University of the Philippines OPEN UNIVERSITY

SUPPLEMENTAL BID BULLETIN NO. 24-008

This Supplemental Bid Bulletin No. 24-008 is to amend or modify items in the Bid Documents and in response to the queries raised during the pre-bid conference conducted on 04 April 2024 for “Completion of the Convention Hall of the International Convention Center” to wit:

A SINGLE LINE DIAGRAM
 E 1 SCALE NTS

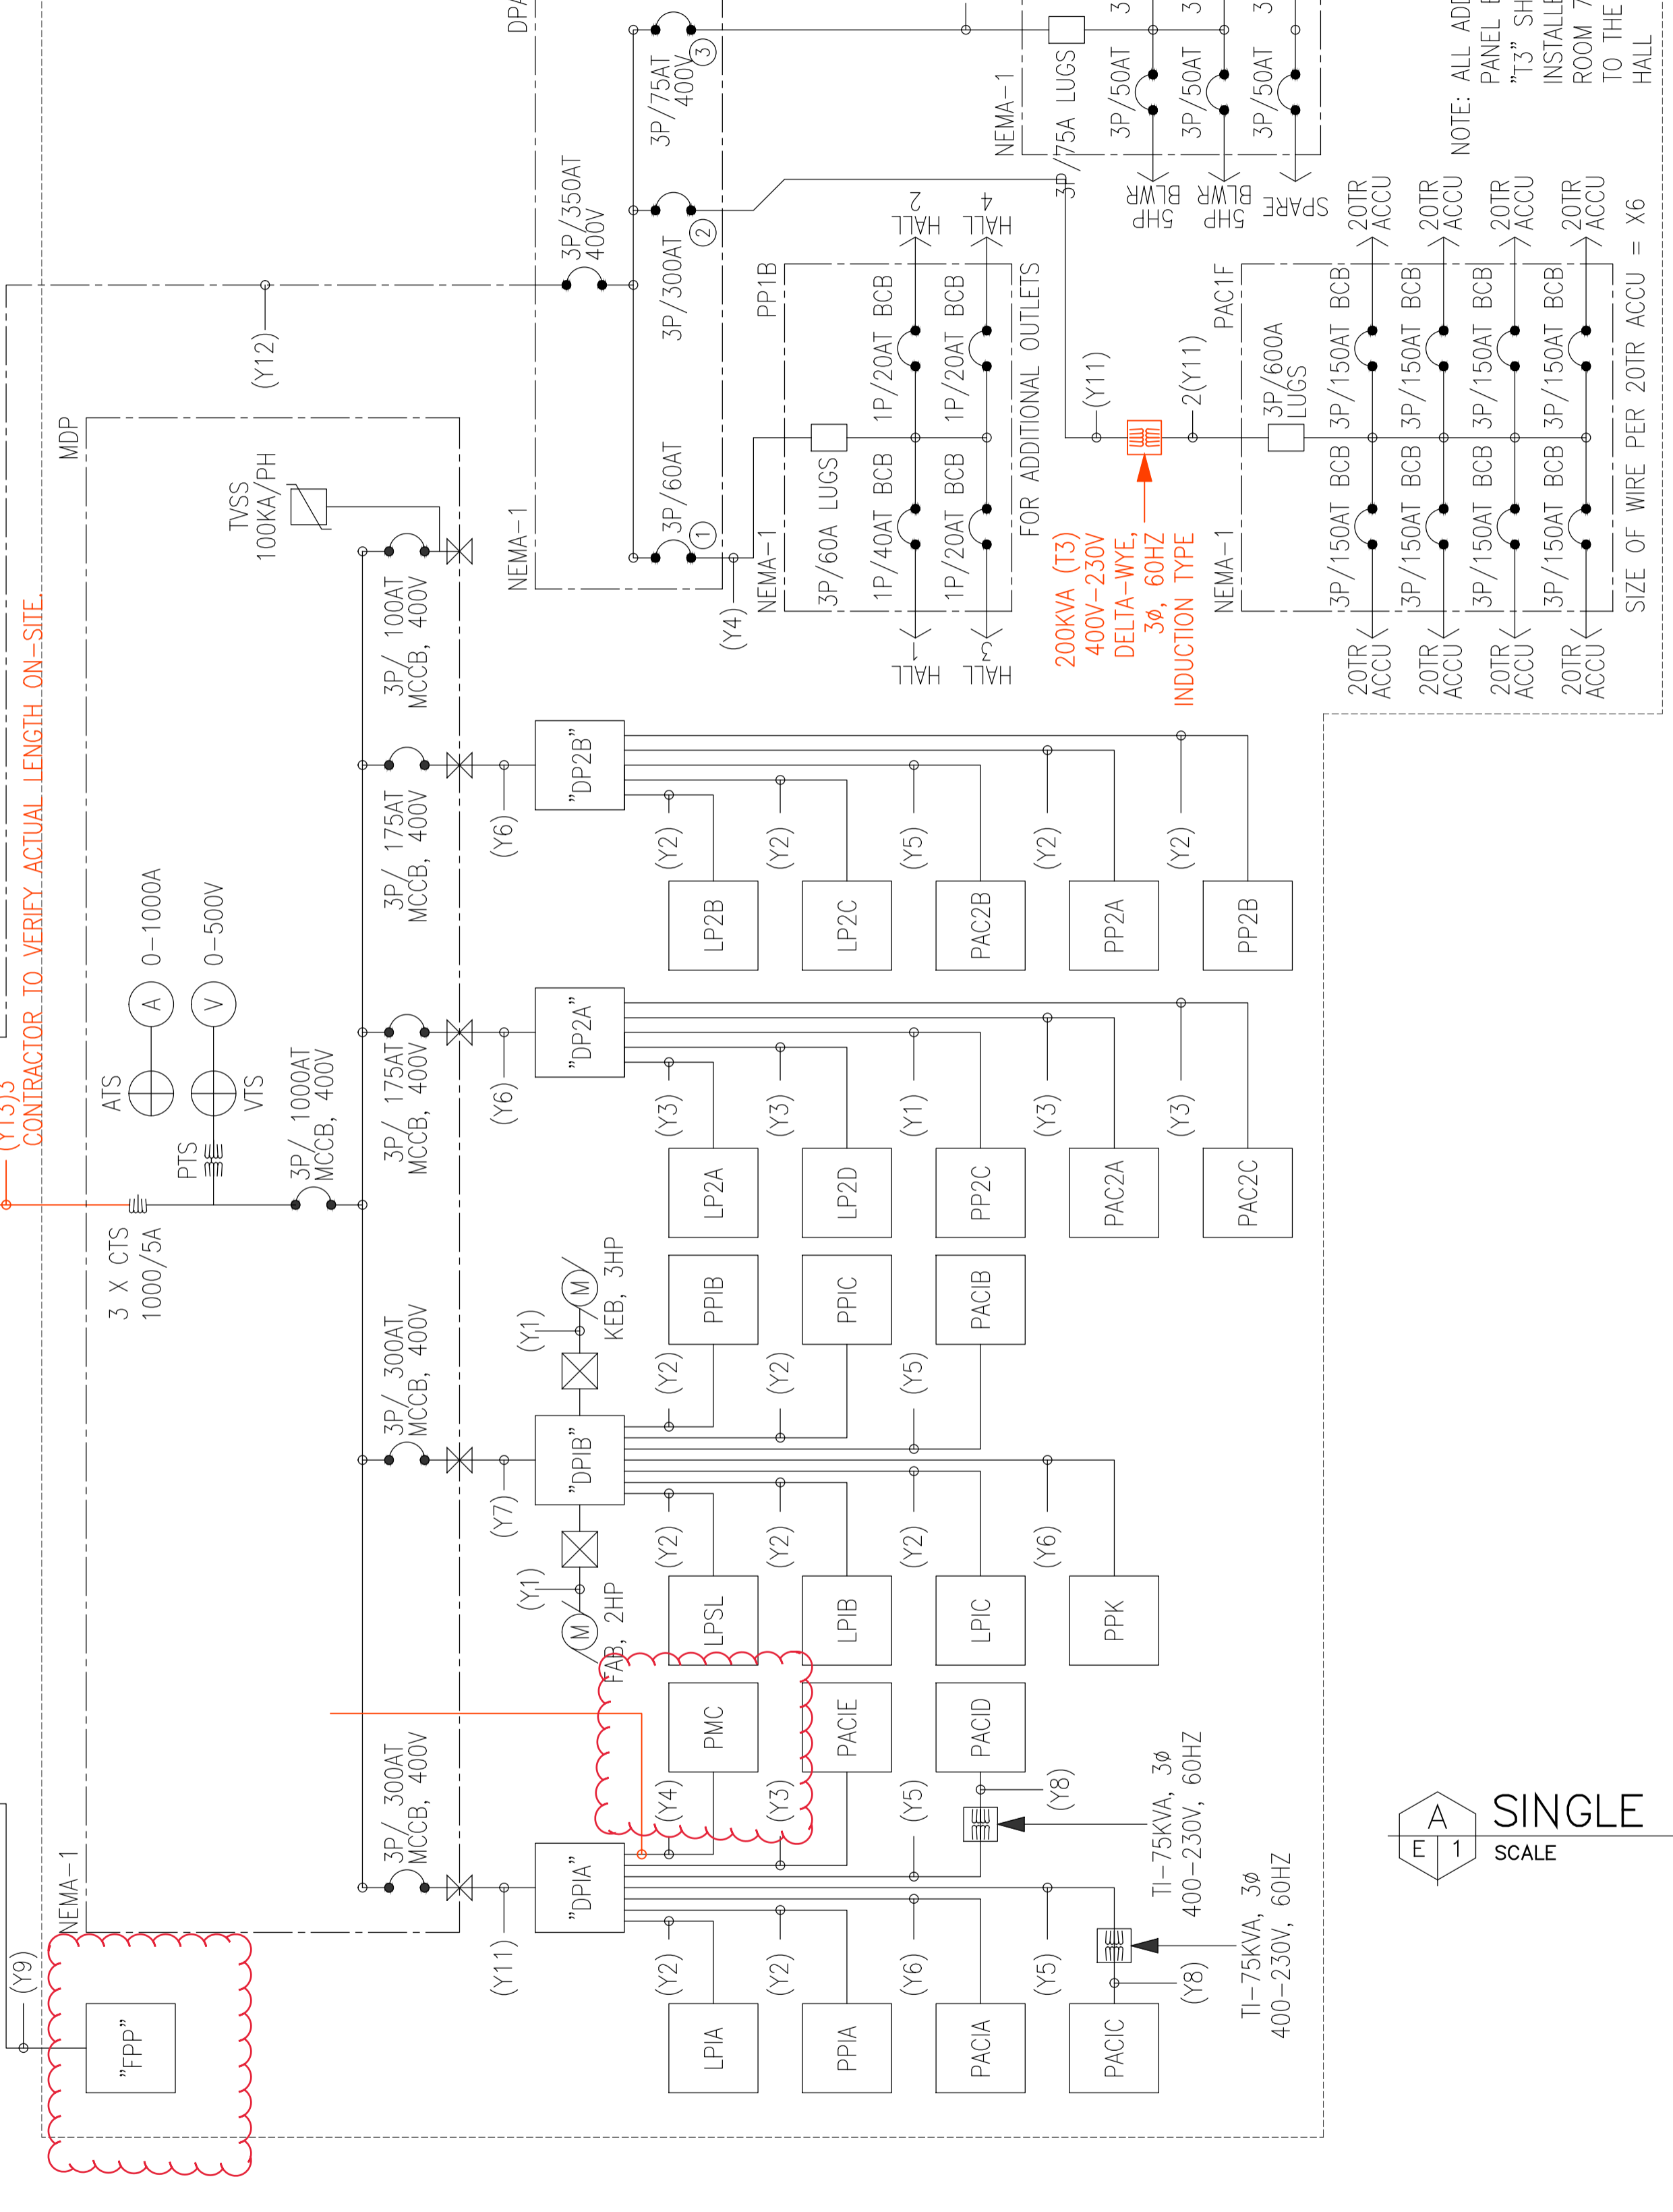
3. Plans, drawing details of the following items of works: F. Electrical Works 1. a. LVSG, 400V, ATS type NEMA 1 free standing b. Panel “PMC” c. Panel “FPP” 2. 200kVA, 400V, 3P-230V, 3P, step down, dry type Transformer NEMA 1, 60 Hz	Refer to the attached single-line diagram for reference. Refer to the power layout (E-2) for reference.
